GZI Boren LLC

3.0 SUMMARY OF RECOMMENDATION MEETING 1 COMMENTS

DRB Recommendation Meeting 2 | SDCI Project 3029383 | 2020 January 21 | Gensler | GZI Boren, LLC.

4.0 RESPONSE TO RECOMMENDATION

Section cut between boren and alley entry points

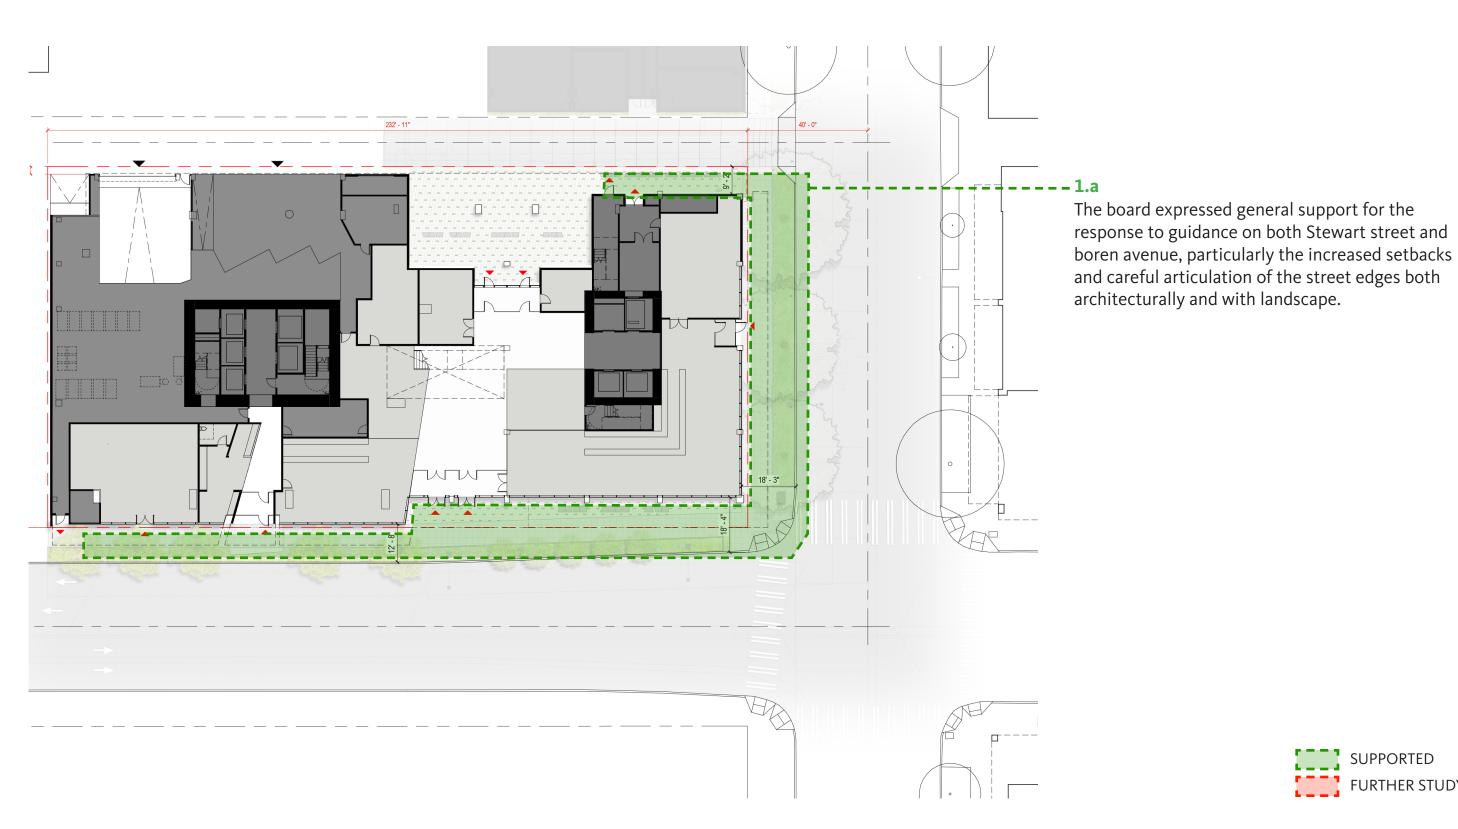
The board encouraged the re-establishment of a strong connection between the street edge lobby and the port cochere area at the alley, noting that relocating intervening program elements could be part of a solution.

Recommendation 1

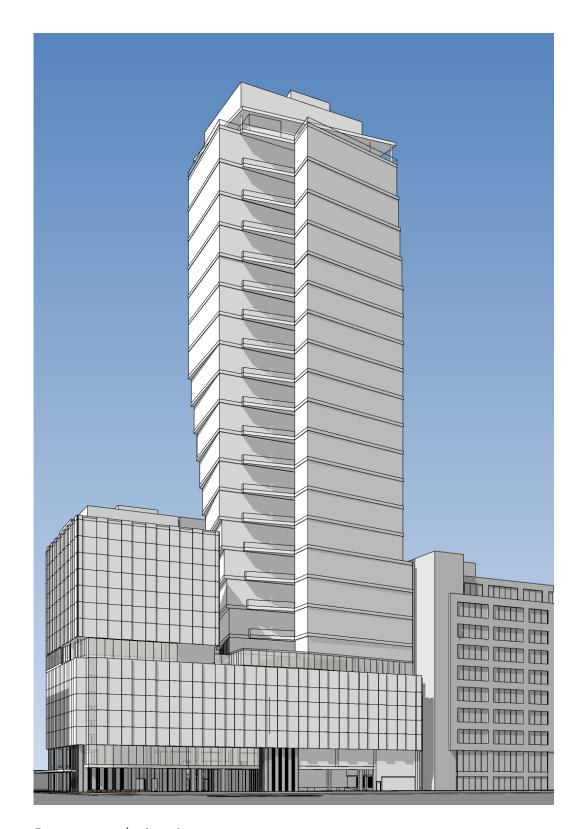
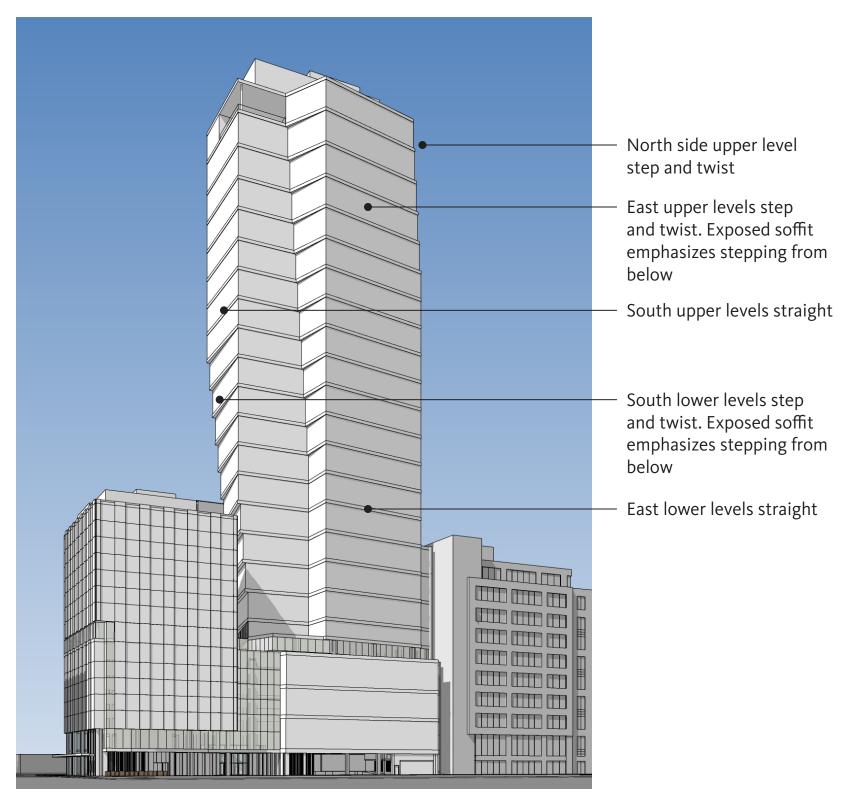
- **4.b** The Board agreed that the smoother (vs. EDG-2) steps and twists could be part of an effective strategy but found the limited and discrete application of this move to be unconvincing. The Board noted that applying this approach to the whole form could be an effective strategy to create a more coherent design concept that is responsive to their previous guidance.

- **4.c** In response to questions from the applicant, the Board clarified this issue by noting that while there were two moves employed to create the stepping and twisting tower form at the previous EDG meeting, in that case the two moves were very clearly connected. Moving forward, the Board agreed that establishing a clear and legible connection between the moves that generate the twisting and stepping tower form would be essential in creating a coherent design concept and unified expression.

- **4.f** The Board recognized the complexity of this design problem, particularly the application of a unified compositional strategy around the four unique sides of the larger tower. The Board agreed that a responsive solution would integrate the expression of stepping and twisting on all sides of the building in a cohesive and unified whole.

The stepping and twisting at the south face (leaning outward) and the north face (leaning inward) are integrated into the east facade. As the projecting form of the eastern volume rises, the southeastern corner steps and twists toward the top. This is echoed at the top of the northeastern corner. The resulting tower expresses the stepping and twisting of the concept at each face and from top to bottom creating a unified tower.

Recommendation 1

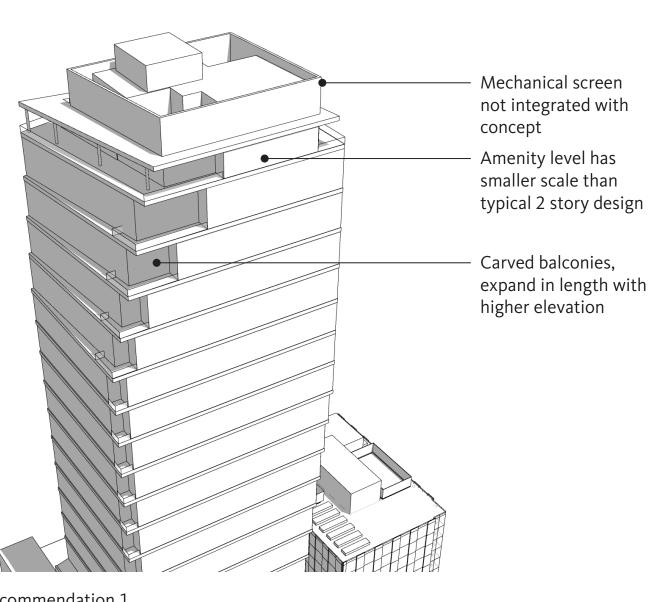
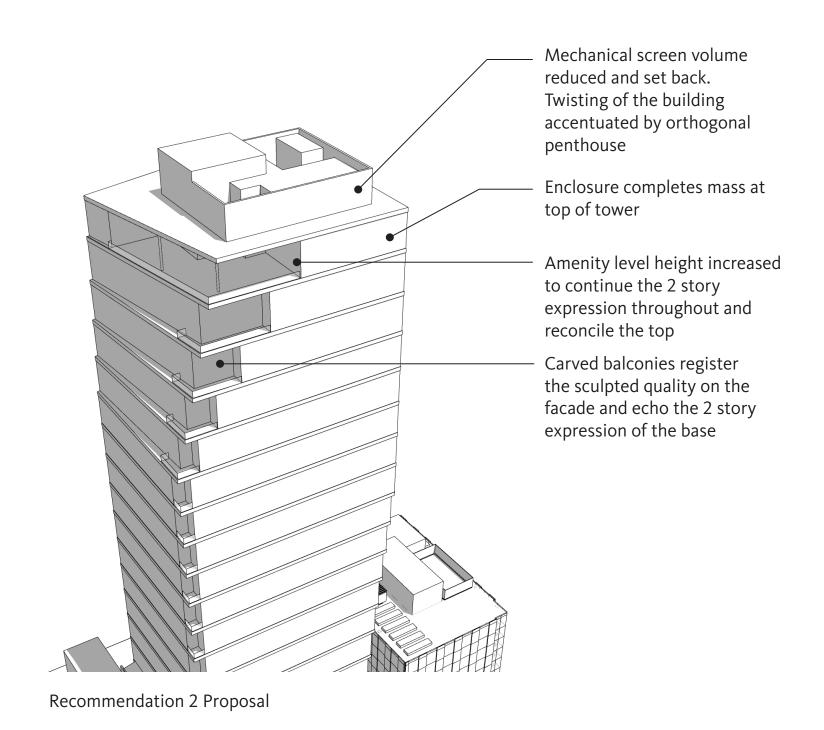
- **4.d** The Board supported the erosion of mass on the north of the tower but found the termination of this expression difficult to reconcile with the concept. The Board recognized and supported the historical context-generated rationale for this move but found its simplified expression and isolation had compromised the quality ("teetering asymmetry") of the historic spite mounds concept that were identified as its generator.
- **4.e** The Board did not support the rooftop mechanical screening as currently proposed and provided guidance to explore options that would better integrate this element with the larger composition.

The top of the tower is resolved by creating a two-story expression at the uppermost floors, consistent with those below. The topmost eyebrow expresses the final twist and step of the north facade. The volume of the mechanical penthouse is reduced and the face of the screening is recessed from the face of the tower to provide differentiation.

The carved balconies at the top of the tower at the northwest corner take part in the twostory expression, express the sculpted quality of the tower on the facade and together with the stepping at the base of the tower further create a unified building.

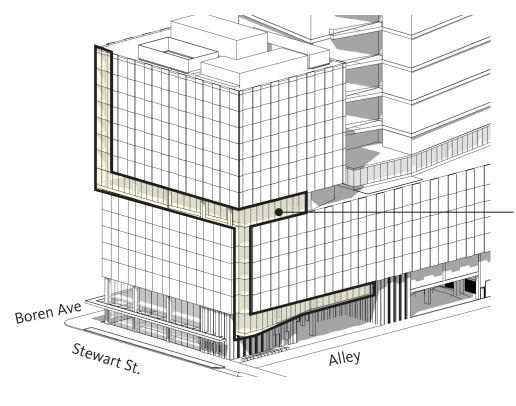
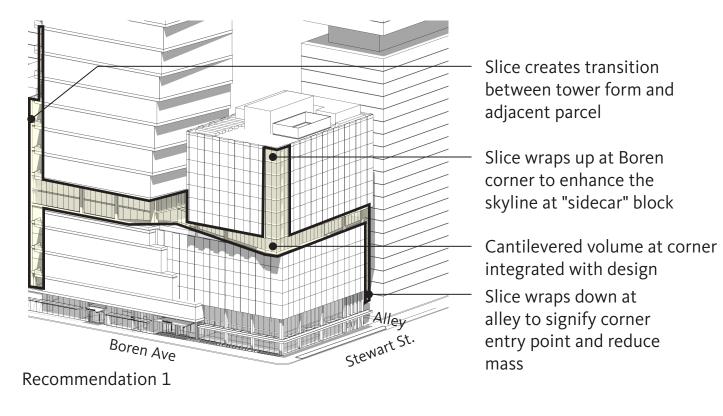
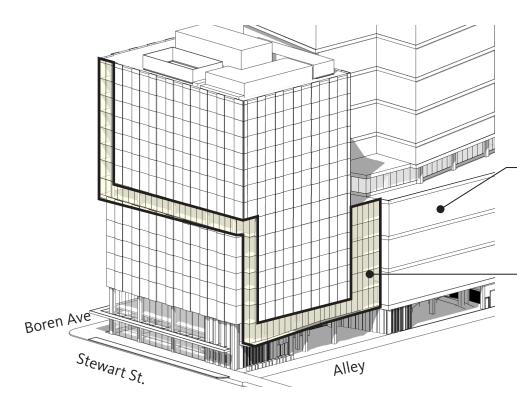
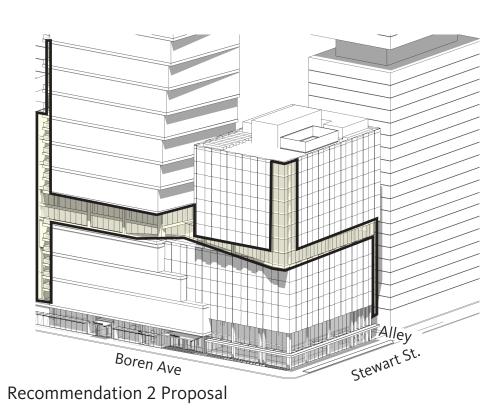
- **3.a** Some Board members found the revised design to have effectively developed this element as a standalone, complementary expression, and supported the clear exterior expression of program areas.
- **3.b** Other Board members found the identical expression of the tower/top and base/ podium (split by the double-height amenity expression) to be illogical and not clearly responsive to guidance.
- **3.c** The Board discussed the viability of several approaches to this element and agreed that a number of strategies for integrating these elements in a coherent architectural concept could be successful.

The design team agrees with the board members' 3a comment. In an effort to strengthen the reading of the tower and sidecar volumes, the expression of the tower has been brought to the ground at both Boren and the alley facades. This allows the sidecar tower, with its vertical articulation to be distinctly expressed.

The amenity ribbon continues to express that program at an urban scale. This element has been revised as it transitions at the Stewart Street / alley corner of the building to allow the sidecar volume to be expressed along its full height. That ribbon resolves itself vertically above the porte cochere to both mark the alley entry and allow the tower volume to come down to the ground.

Recommendation 1 - Pedestrian View from Boren

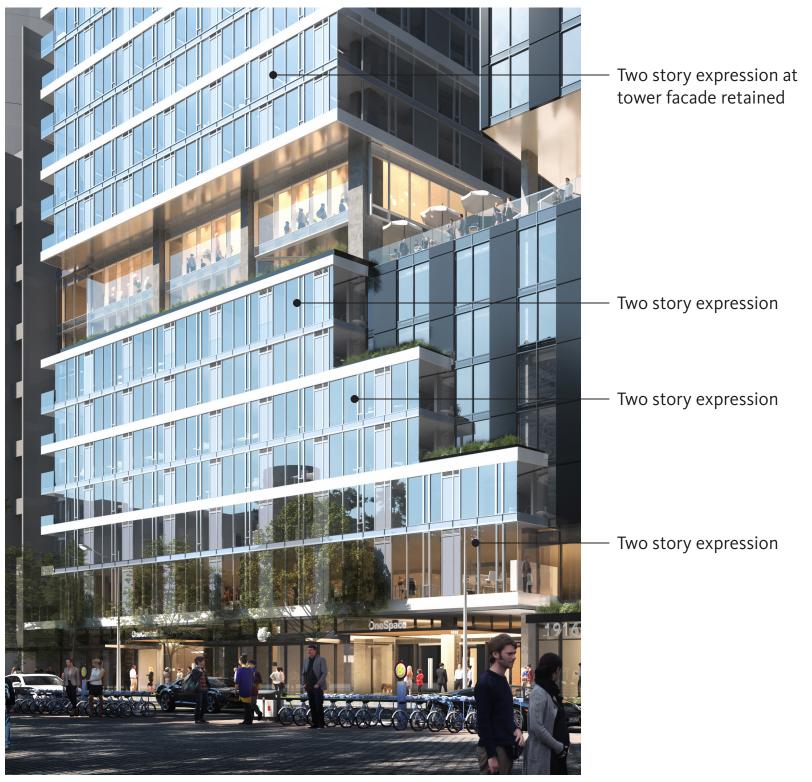
2.a The Board supported the two-story expression of this element and agreed that the green roofs at the canopy were compositionally strong and responsive to guidance, bridging and connecting the landscape elements above and below.

During the initial Recommendation meeting, the Board noted a preference for a consistent two-story stepping at the base of the tower. To further strengthen the design, the project has been revised to provide two story stepping from street-level up to the top of the podium. This ties the base of the tower into the upper portion with a consistent expression.

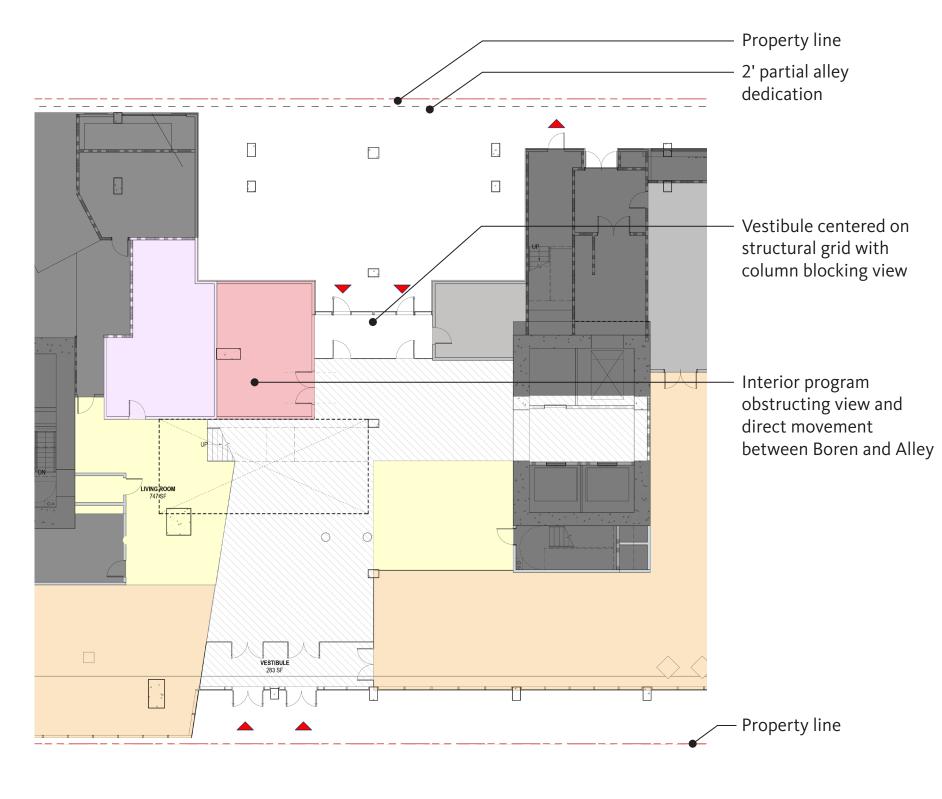
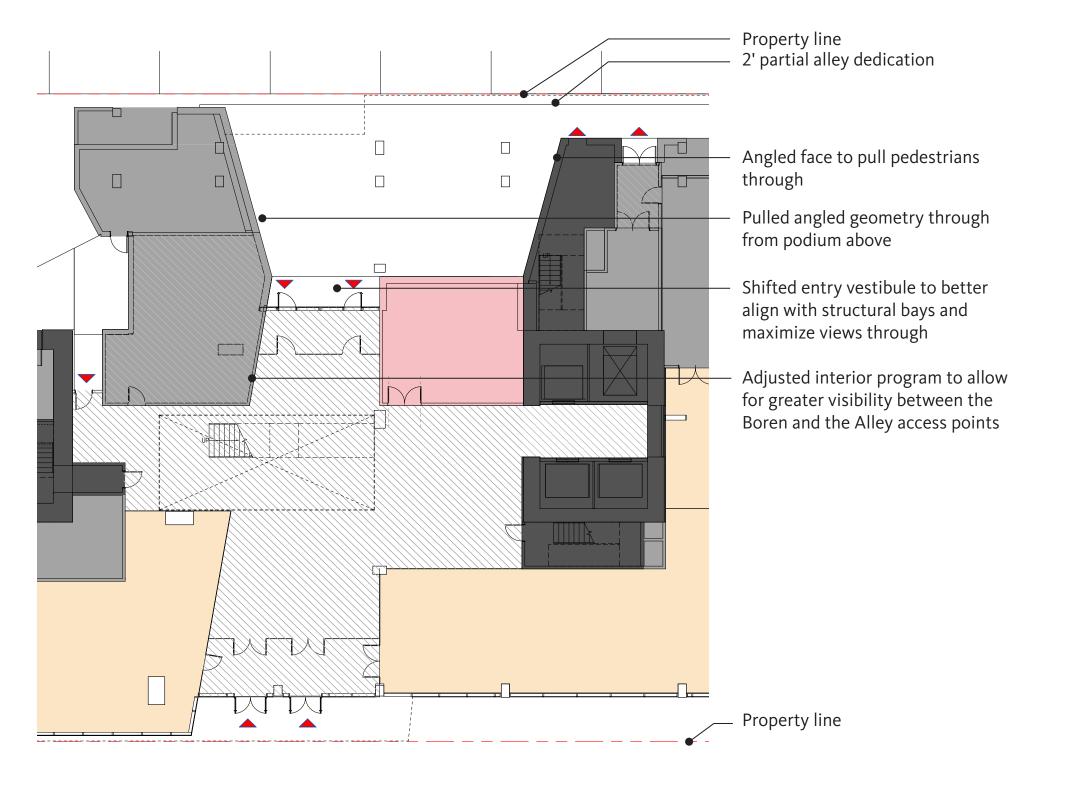
- **1.c iii.** Further development of the porte cochere area in the ground plane using revised program and layout of columns as organizing elements
- **1.c iv.** Developing the walls of the porte cochere to be carefully articulated and attractive elements, in particular the (Northwest) wall that will be most visible from the street

The direct visual connection from Boren Avenue through the building to the alley porte cochere is strengthened. The alley entry location has shifted to create better alignment through the building while working with building structure.

The angle of the wall immediately adjacent to the main entry is echoed at the alley entry, providing a destination at the entrance to the alley. This angled wall at the northern end of the porte cochere is further integrated into the tower volume above. Articulated precast concrete panels flow from the alley corner through to the porte cochere creating a continuous, attractive pedestrian experience.
